Engineering Bulletin: **ECR00187**

Systems Affected: **400TU**

Subject: **S425-OR and S479-OR pressure
plate screws for 400TU**

S425

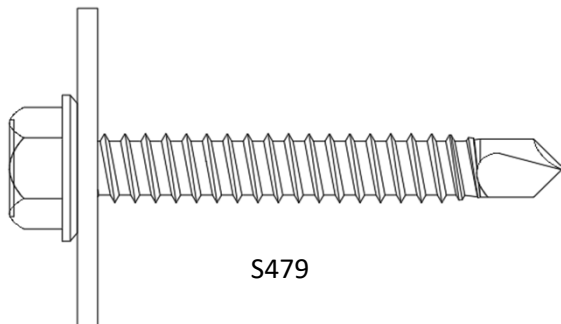
The 400TU curtain wall system will now use the S425 pressure plate screw with aluminum pressure plates and the new PTB120 thermal pressure plate. This screw will provide better torquing and is more resistant to stripping than the S400-OR. When polyamide pressure plates are required, the S479 is used, which is the combination of the S425 screw plus the S437 flat washer.
